**County of Nevada  
Information & General Services Department  
Purchasing Division**

**ADDENDUM NO. 3 (Redesign)  
McCourtney Road Transfer Station  
(MRTS) Improvement Project**

**Addendum Release date: January 4, 2023**

1. Seven sheets have been modified for this addendum; Architectural pages 02A203, 02A302, 02A303, 02A504, and Structural pages 02S402, 03S103 and 03S302, and have been uploaded as two separate documents in Public Purchase

02S402

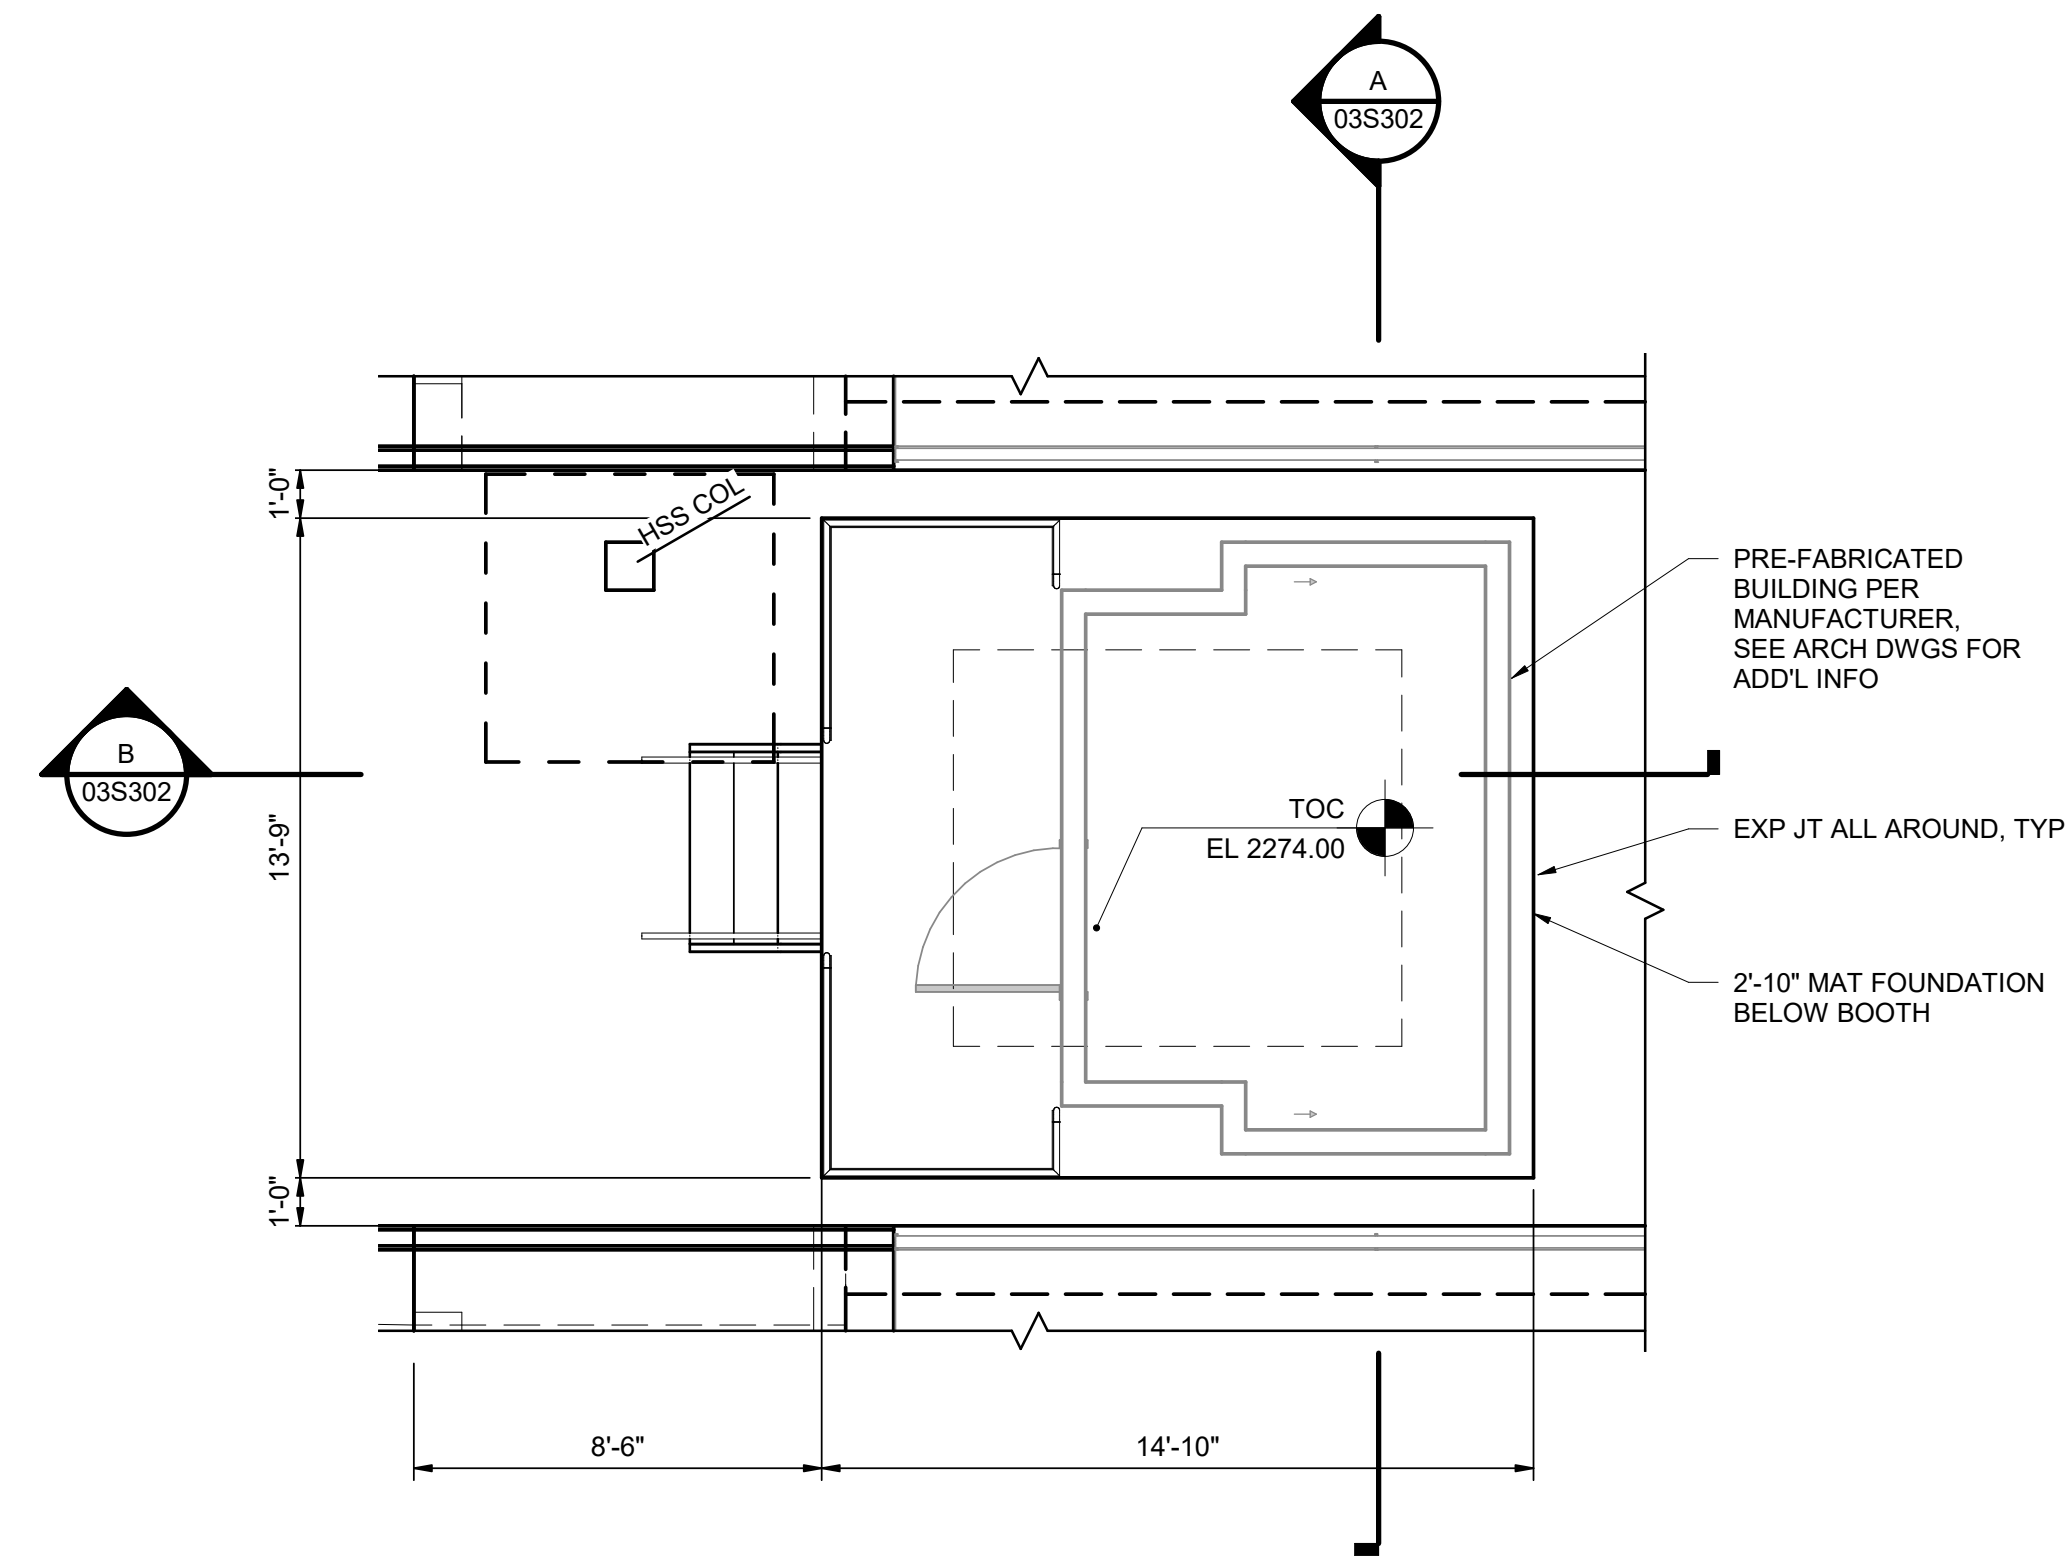
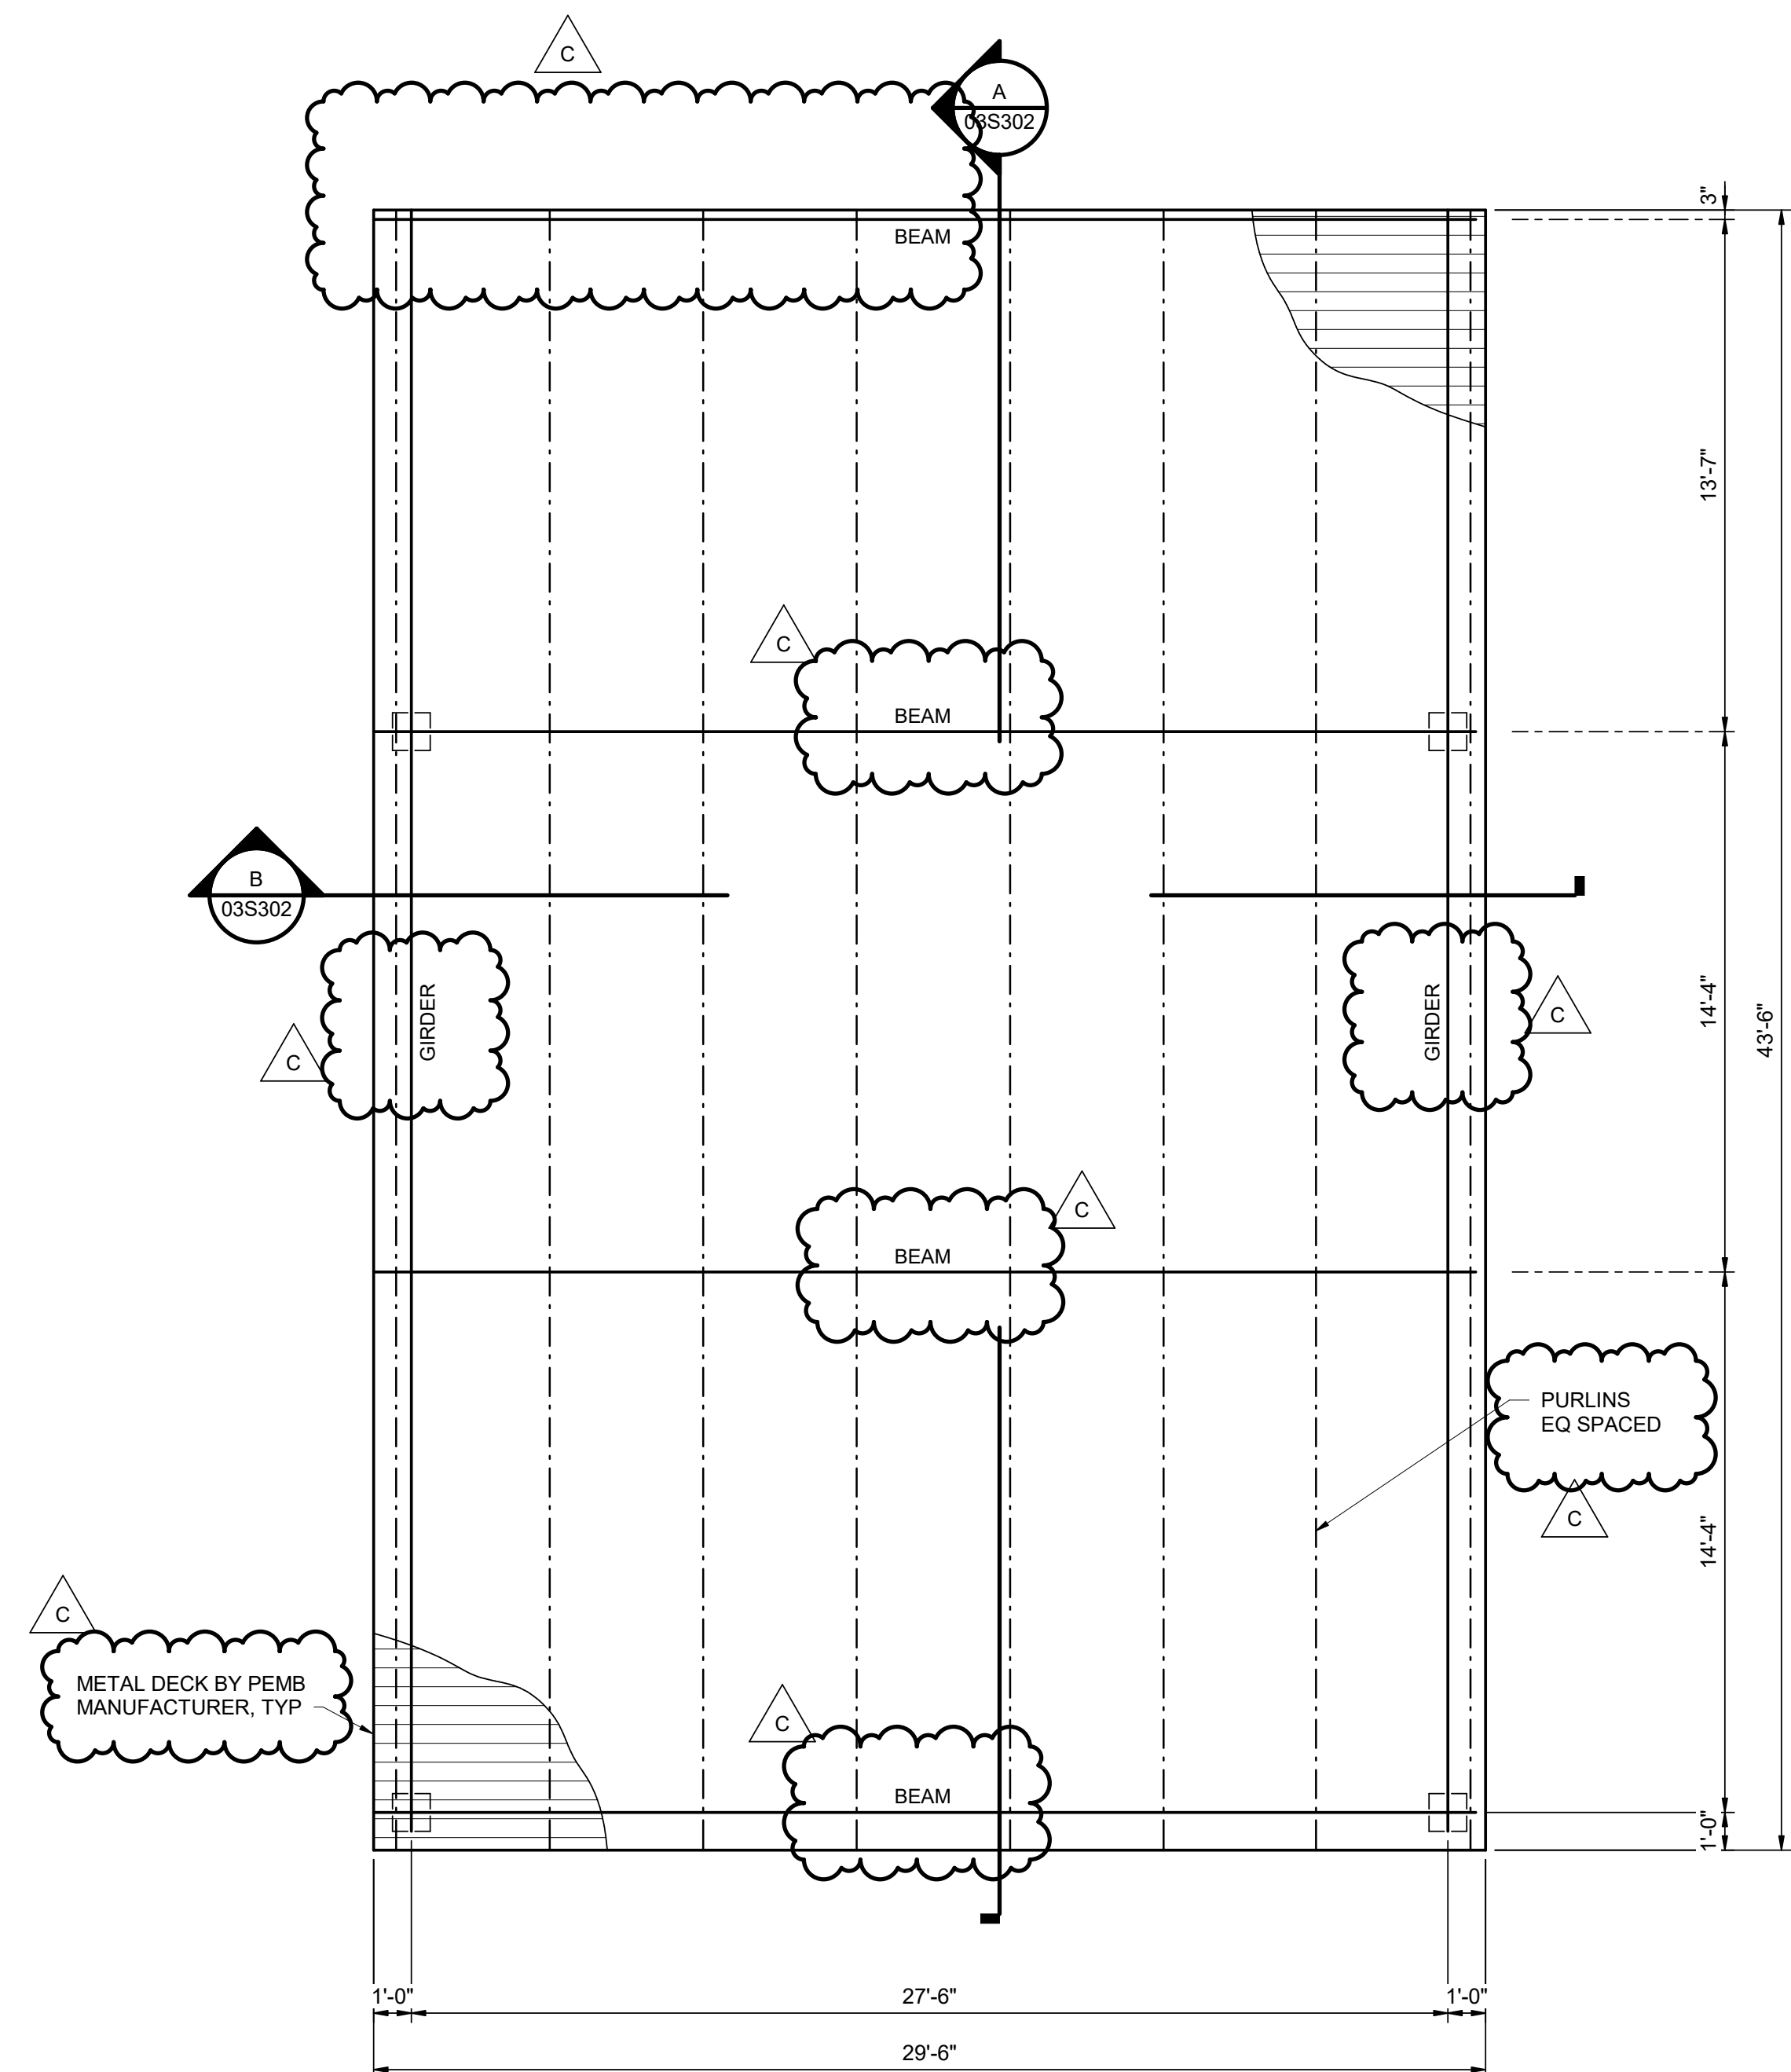
3.	<p>Reference 02A504 seems to call out plywood decking; 02S402 seems to call out metal roof decking. Q - Please clarify</p>	<p>The detail will be revised to show metal roof decking instead of plywood. In the essence of time, this response will suffice as acknowledging this clarification.</p>
